Solicitation Amendment No. 01

To: Prospective Bidder/Offeror:		Date:	
		July 1, 2011	
Project Title:		Project No.:	
Parking Lot Improvements at Central Campus		Project # 11-26	
Description of Solicitation Amendment:			
<p>The Request for Competitive Sealed Proposals (RFCSP) for Parking Lot Improvements at Central Campus (Project #11-26) is hereby amended as set forth below:</p> <p>Demolition Plan C-4.0 is revised as follows: "Key Note 17 <u>revised</u> to read Existing Traffic Control Box to remain; Key Note 19 <u>revised</u> to read Existing Traffic Signage Pole to remain; Key Note 28 <u>added</u> and read Existing Storm Sewer Manhole to remain; Key Note 29 <u>added</u> and read Existing Traffic Signal Electrical Pullbox to remain."</p> <p>Civil Site Plan C-6.0 is revised as follows: "Key Note 22 <u>revised</u> to read Existing Traffic Control Box to remain; Key Note 23 <u>revised</u> to read Existing Traffic Signal Pole to remain. Contractor shall construct the sidewalk around Traffic Signal Pole; Key Note 25 <u>added</u> and reads Existing Traffic Signal Pullbox to remain. Contractor shall construct the sidewalk around Existing Traffic Signal Pullbox; Key Note 26 <u>added</u> a

DEMOLITION PLAN

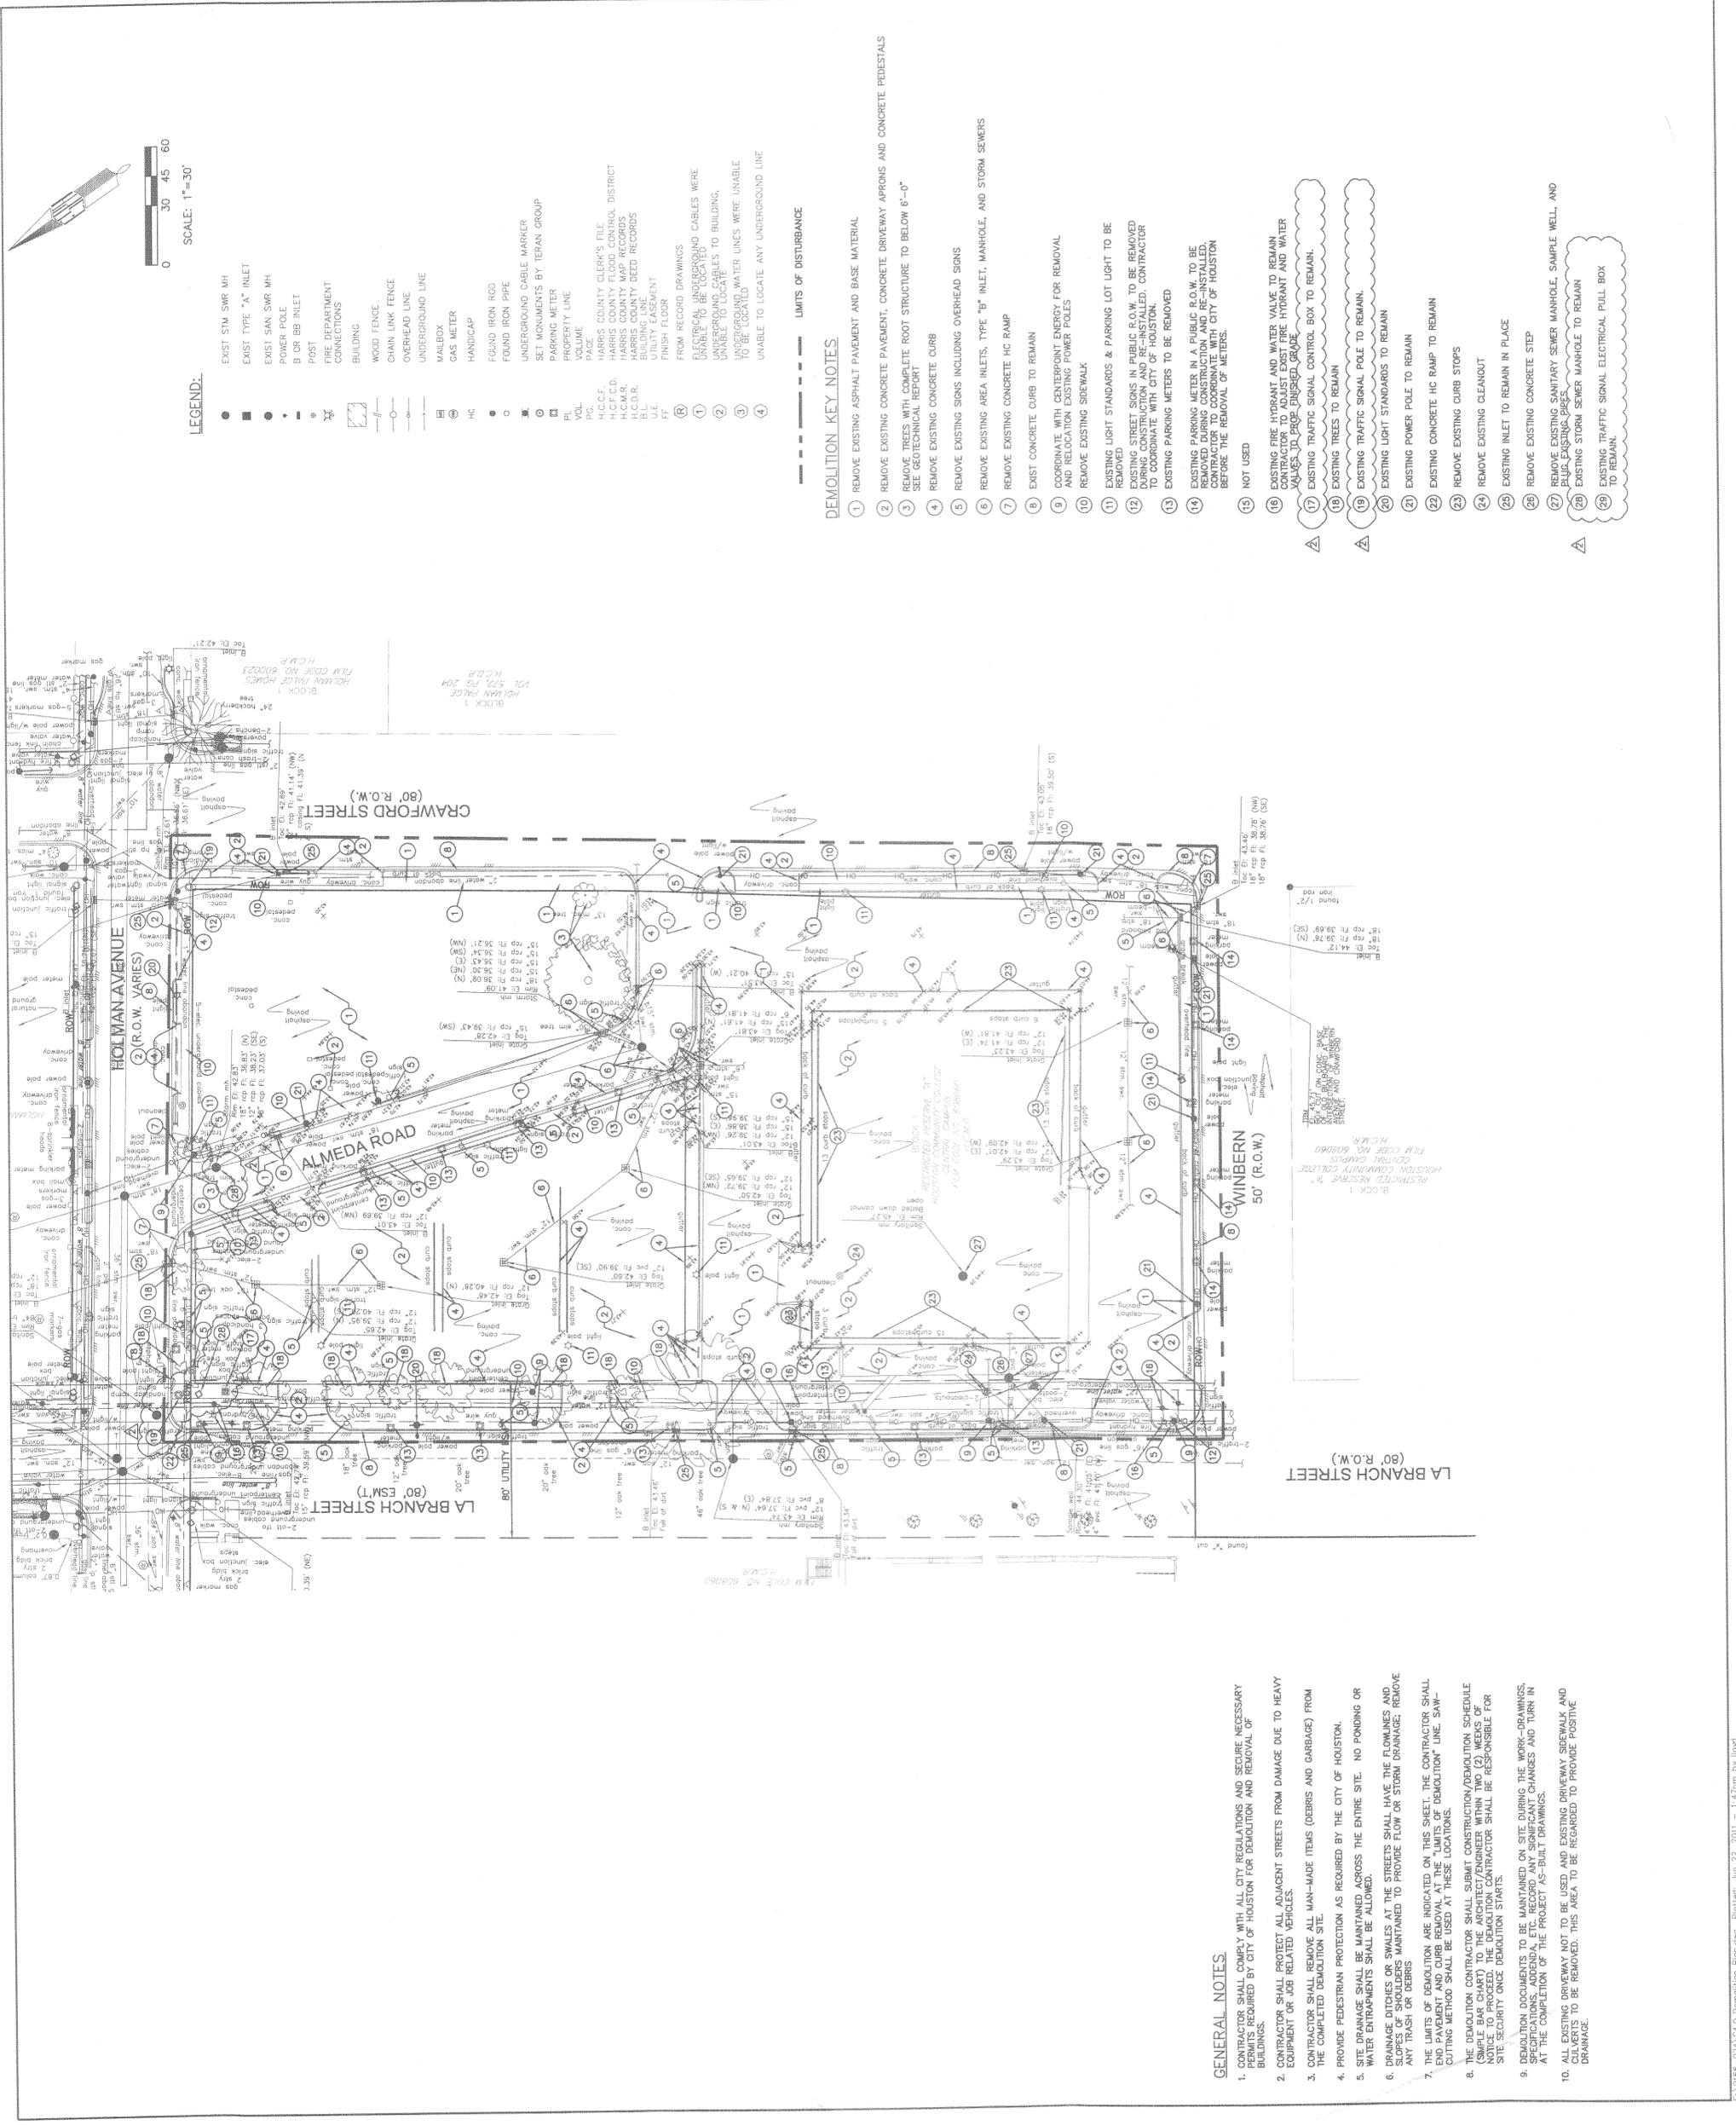
Issue/Revision:	DATE	BY
1 ISSUED FOR Bidding	06/09/11	JA
2 EXIST MANHOLE TO REMAIN	6-21-11	LJO

CIVIL SITE PLAN

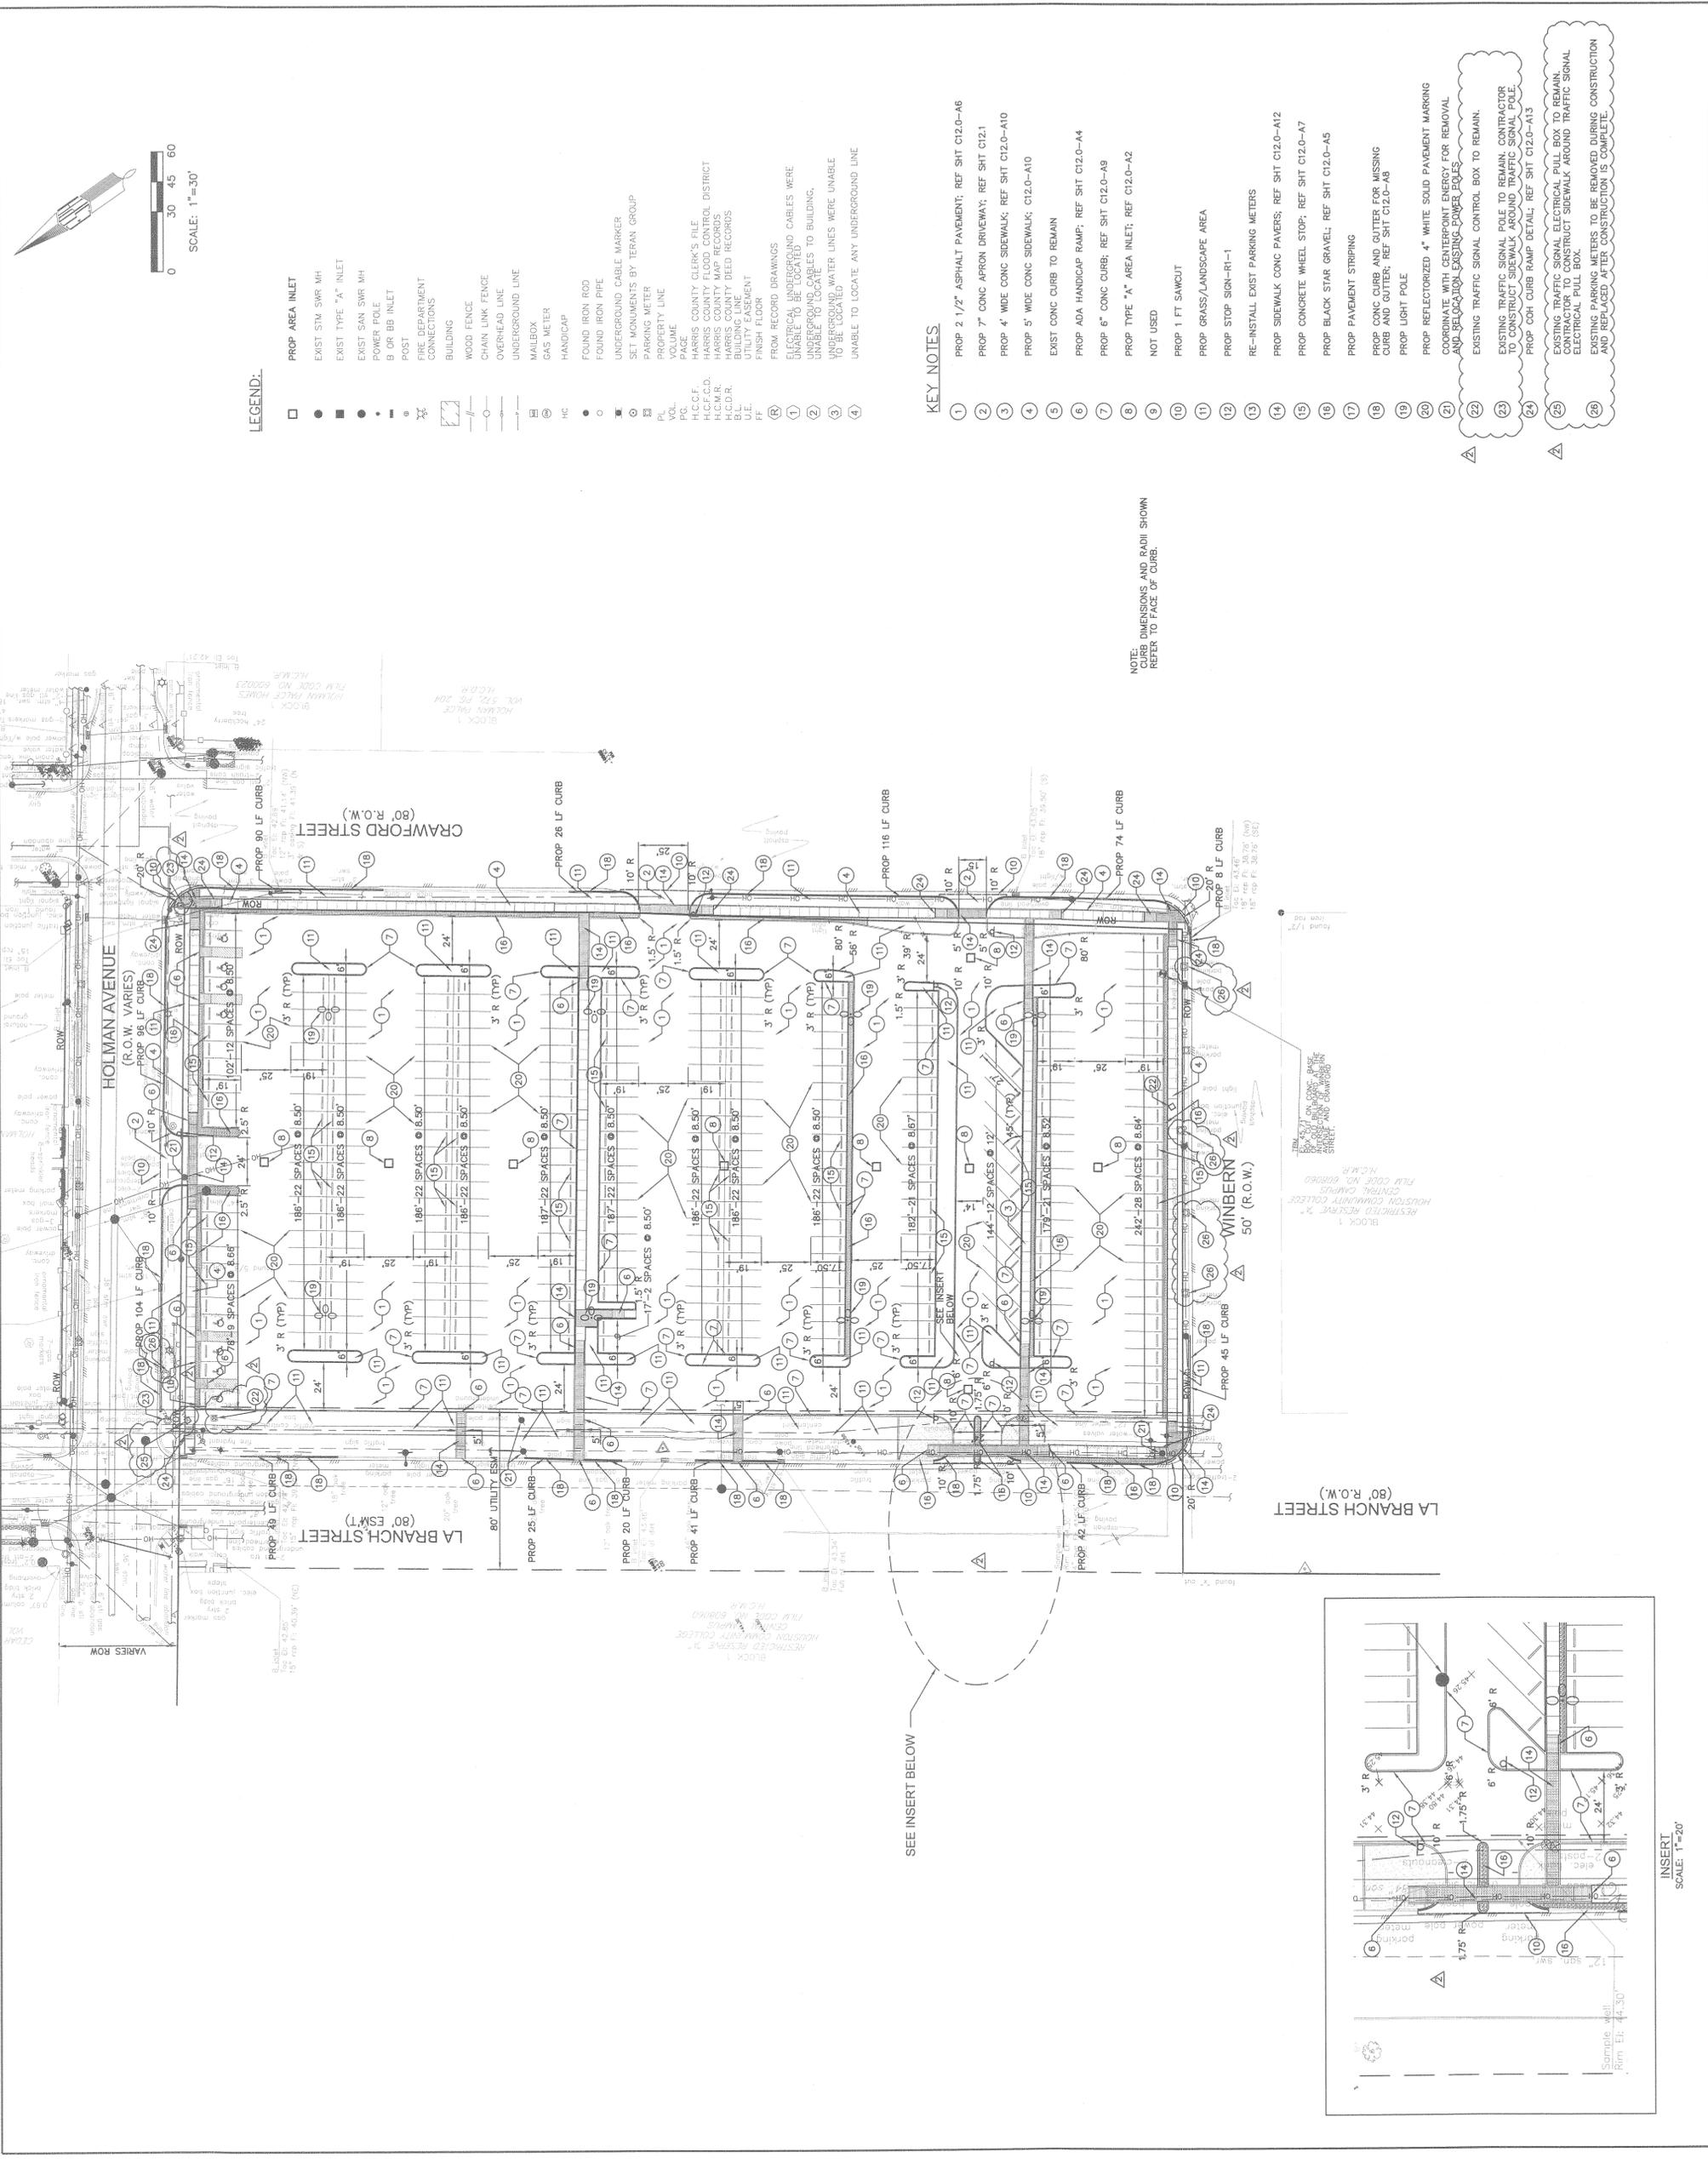
Issue/Revision:	REV	DESCRIPTION	DATE	BY
	1	ISSUED FOR BID & CONSTRUCTION	06/09/11	JJA
	2	REV KEY NOTES 22,23,25 & 26	LJO	
	3	& DELETED DRIVE INTO		
	4	PARKING GARAGE

2 LIGHTING CONTROL PANEL WIRING DIAGRAM
NOT TO SCALE

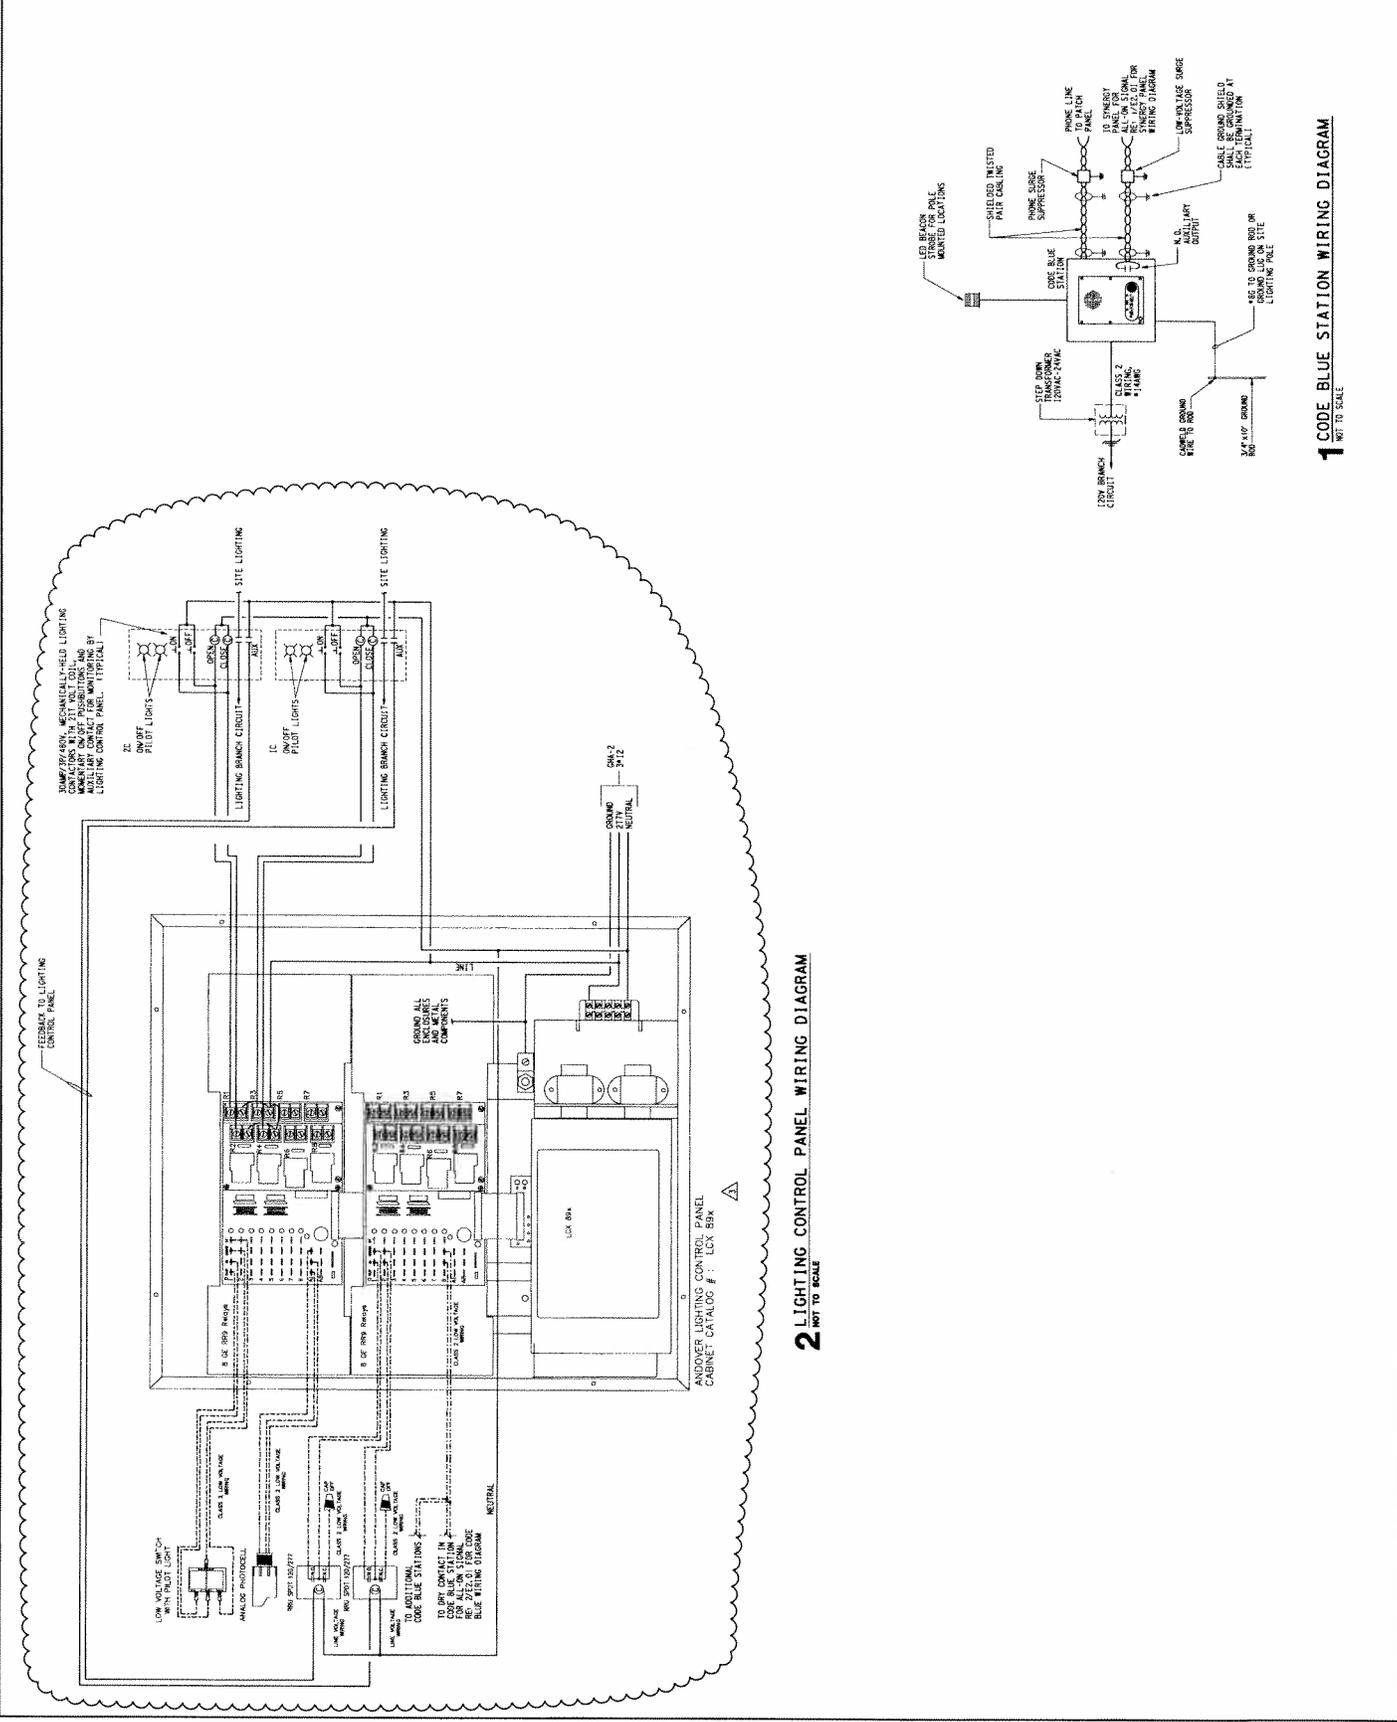
<p>Section 26 09 43 – LIGHTING CONTROLS is hereby replaced in its entirety and attached herein.</p> <p>Electrical Details SE301, Lighting Control Panel Wiring Diagram is hereby replaced in its entirety and attached herein.</p>		Company	Address	Telephone	Associated General Contractors	3825 Dacoma Street, 77092	(713) 843-3700	McGraw-Hill Dodge Plan Room	10606 Hempstead Rd, 77092	(713) 681-2603	Associated Builders & Contractors	3910 Kirby, Suite 131, 77098	(713) 523-6222	Houston Minority Development Center	4801 Woodway, Ste 210, 77056	(713) 644-0821”
Company	Address	Telephone														
Associated General Contractors	3825 Dacoma Street, 77092	(713) 843-3700														
McGraw-Hill Dodge Plan Room	10606 Hempstead Rd, 77092	(713) 681-2603														
Associated Builders & Contractors	3910 Kirby, Suite 131, 77098	(713) 523-6222														
Houston Minority Development Center	4801 Woodway, Ste 210, 77056	(713) 644-0821”														
Acknowledgement of Amendment No. 02 by:	Date:															
Company Name (Bidder/Offerer):																
Signed by:																
Name (Type or Print):	Title:
